## INFORMATIONAL PRODUCT ADVISORY

**DATE:** March 9, 2026  
**RE:** Start up issue.  
**PRODUCT(S):** TPS5410, TPS5420, TPS5430, TPS5431

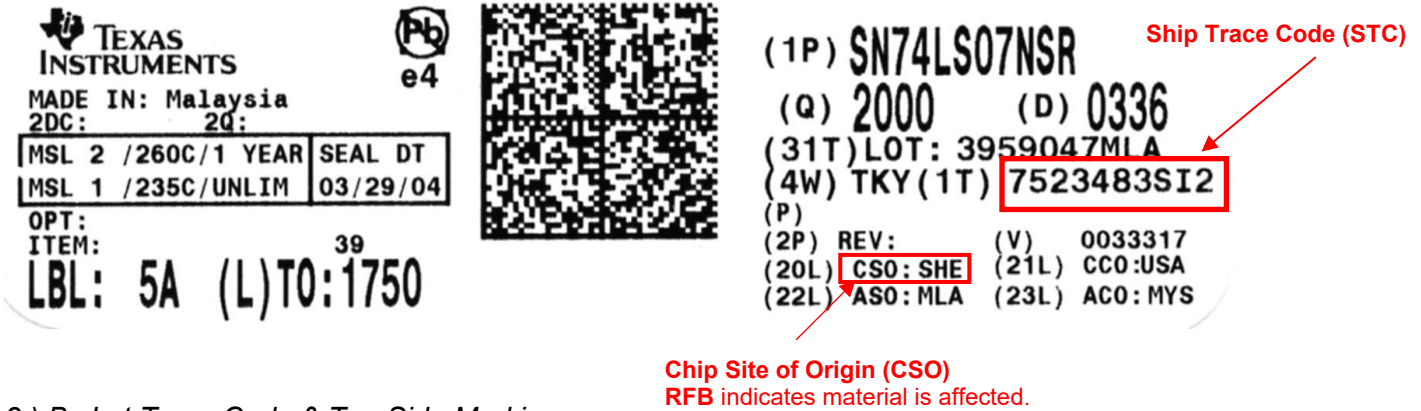
The start up issue may occur at time zero for applications using a resistor tied to the ENA pin with a value less than 1.5Mohm. This only applies to units that were manufactured using the flow which was announced in the 20240424000 and 20231219004 Product Change Notifications (PCNs). To identify existing affected product, check the shipping label for the TI TPS54xx products you have in stock. In the CSO field it will say RFB for affected product. If the customer does not have the shipping label, it is possible to identify affected products by using the top marks on the products. The customer will need to contact their TI representative to decode that information. This will potentially affect all products shipped in the future under the preceding PCNs.

For applications that are affected, this issue is correctable by removing any resistor attached to the ENA pin or by adjusting the resistor value to be above 1.5Mohm. TI will support customers to review the application design to accommodate PCN material. The customer will need to contact their TI representative for this support.
